Assessment Report

Case reference	SMC-ABS-003 (related to SMC-ABS-004)
Application details	Addition of symbol stones and stone shelter
Site address	The Bass and Little Bass, motte and bailey castle, Inverurie (SM 74)
Applicant	Aberdeenshire Council
<b>Determining Authority</b>	Historic Environment Scotland (HES)
Local Authority Area	Aberdeenshire Council
Reason(s) for notification	Notification Direction 2015 – works to be granted Scheduled Monument Consent by <b>Historic Environment Scotland</b> go beyond the minimum level of intervention that is consistent with conserving what is culturally significant in a monument
Representations	Nil
representations	1911
Date notified to Ministers	14 June 2018
Date of recommendation	26 June 2018
Decision / veces manufation	Class
Decision / recommendation	Clear

Below: Plan showing original location and proposed location.

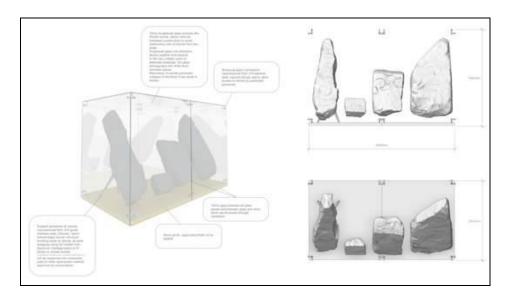
- Historic Environment Scotland (HES) are minded to grant SMC for the
  installation of the relocated carved stones and construction of a new glass
  shelter to encase the stones, which will impact on the Scheduled Monument as
  the installation goes beyond the minimum level of intervention which is
  consistent with conserving what is culturally significant in the monument. This is
  a significant departure from policy as set out in section 3.16 of the HES Policy
  Statement.

- 3. The glass shelter would measure 2.94m x 1.62m x 1.84m and be built on a stone plinth with ground disturbance limited to a depth of no more than 0.3m in an area

of low archaeological potential. All ground breaking works will be monitored by an archaeologist to ensure no archaeological deposits are disturbed. The stones would be ventilated and protected from water and sap within the shelter, while being displayed at a slight angle to permit better perception of carved relief detailing on the surface. The new location adjoins the footpath and graveyard. It will be visually separated from the main elements of the motte and bailey earthworks by a pre-existing fence.

- 7. HES require two conditions to enable the application to be considered fully compliant with paragraph 3.20 of their policy statement. The conditions require the applicant to i) inform HES of the commencement of works to enable a representative to monitor the work; and ii) provide a Written Scheme of Investigation (WSI) prior to commencement of works to be approved by HES, and implemented on site.
